1972 F7-A

PARTS DIAGRAM

SWING ARM/SHOCK ABSORBERS ('71-'73 F7/F7

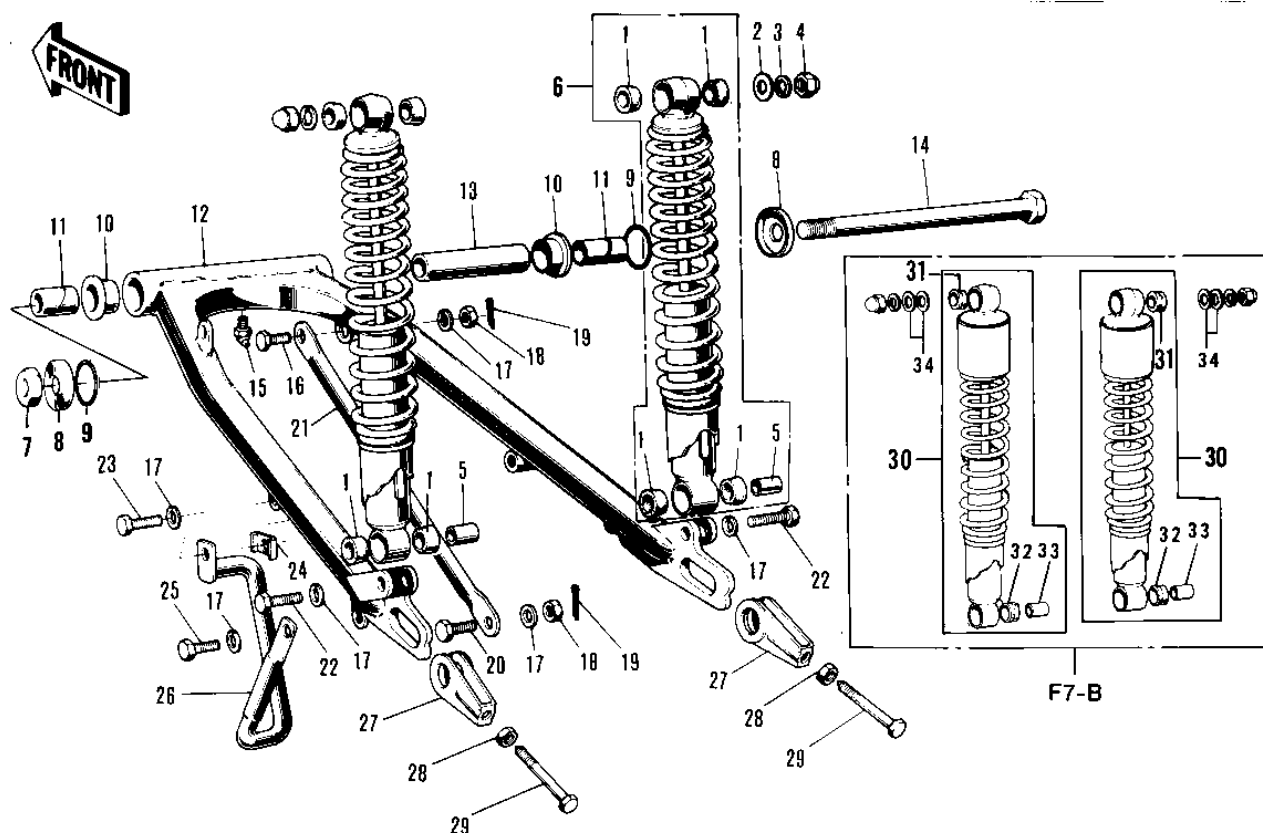
Ref. No. 27, Chain Adjuster		
	OLD	NEW
	1.6 mm 15.2 mm 	3.2 mm 13.7 mm
Chain Adjuster	33041-041	33041-048
Collar	42032-027	42032-036
Frame No.	~20779	20780~
Interchange?	Use new parts as a set in place of old parts.
